TOWNSHIP OF WEST ORANGE

TO: Zoning Board Members

FROM: Paul Grygiel, AICP, PP, Township Planning Director

RE: **ZB-21-05/Tamay**
Block: 125.02; Lot: 100; Zone: R-T
60 Cherry Street
Seeking "c" variances to construct an addition to a single-family residence

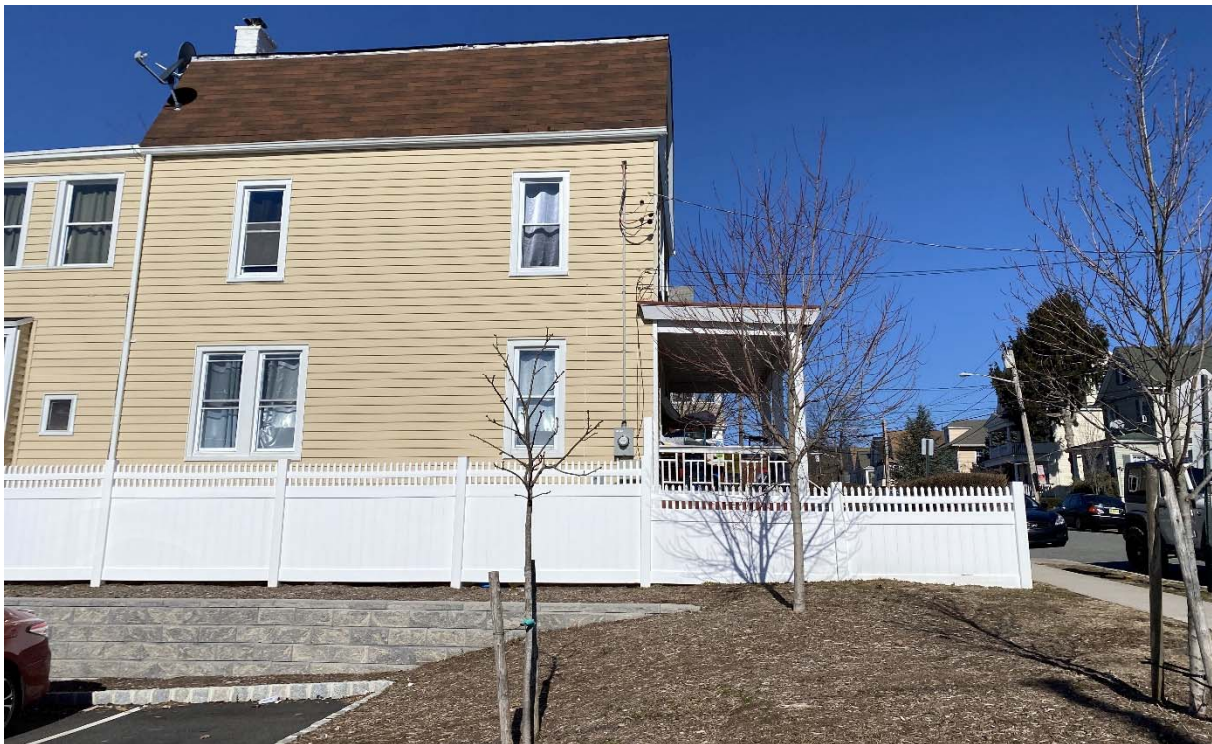
No other changes appear to be proposed to the dwelling or property. The applicant should confirm that is the case.

There is a discrepancy between the lot and building coverages listed on page 2 of the application form and the zoning table on the architectural plans. The applicant should confirm which figures are correct.
